81141A-01A-S

S E R V I C E N O T E

81141A - 7 GHz Serial Pulse Data Generator

There is an unlikely possibility of an instrument catching fire due to a short-circuit

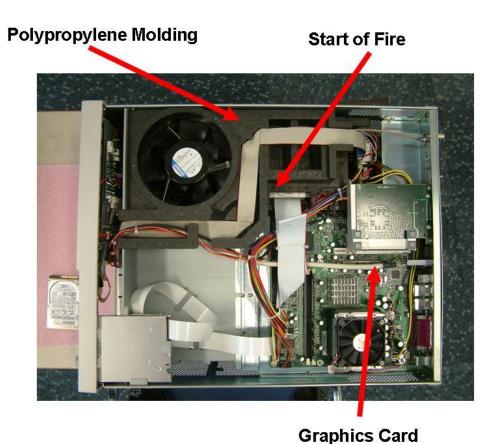
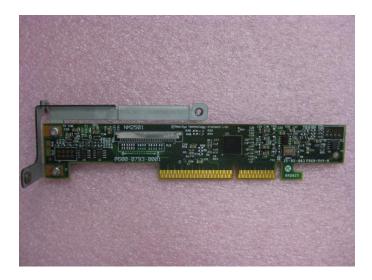
A surface-mount ceramic capacitor suffered physical stress during the manufacturing process, leading the capacitor to crack. During operation this crack placed stress on the internal structure of the capacitor, and caused the plates to short together. (The plates are separated by very little space, made up of very thin insulators.) This caused the capacitor to have very low residual impedance, resulting in a very high current conducted through the capacitor and the 12V path on the motherboard for some period of time. The low impedance didn't lead to a current high enough for blowing the fuse. Therefore the higher current was available long enough to create a very high temperature ($T > 300^{\circ}C$) The high temperature ignited the polyurethane molding used to conduct the airflow for cooling through the instrument.

The following photo illustrates the layout of the instrument. If shows the polypropylene molding, the graphics card and the starting point of the fire.

The countermeasure for this issue is to exchange the graphics cards. The new graphics cards are produced with an improved manufacturing process eliminating the risk of micro cracks. They either have an additional fusing to protect the 12V path or they have eliminated the 12V path altogether. The graphics card can be exchanged by Agilent authorized personnel only.

Sample #1 (Revision NM2501):

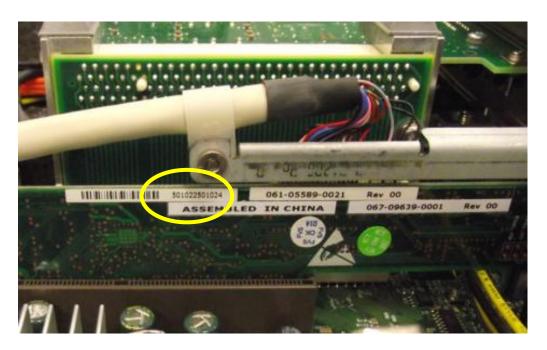
The board has a fuse on top (red circle) and a serial number (yellow circle) starting with 200... In the case above it is 200719049572)

o Sample #2 (Revision NM2502):

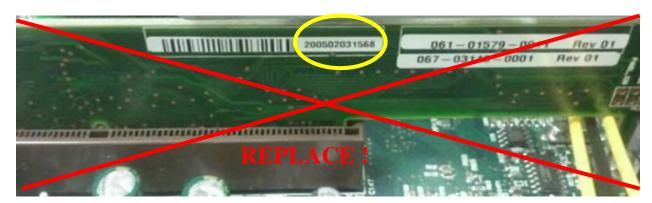
The board has a serial number (yellow circle) ${\bf NOT}$ starting with 200... In the case above it is: 501022501024.

shows a serial number starting with 200... AND no fuse is visible

it is potentially **hazardous** and the **unit must be set out of operation** until the graphic board is replaced (part number: N4901-66577 or N4901-69577). The graphic board can be exchanged without impacting the instrument's performance.
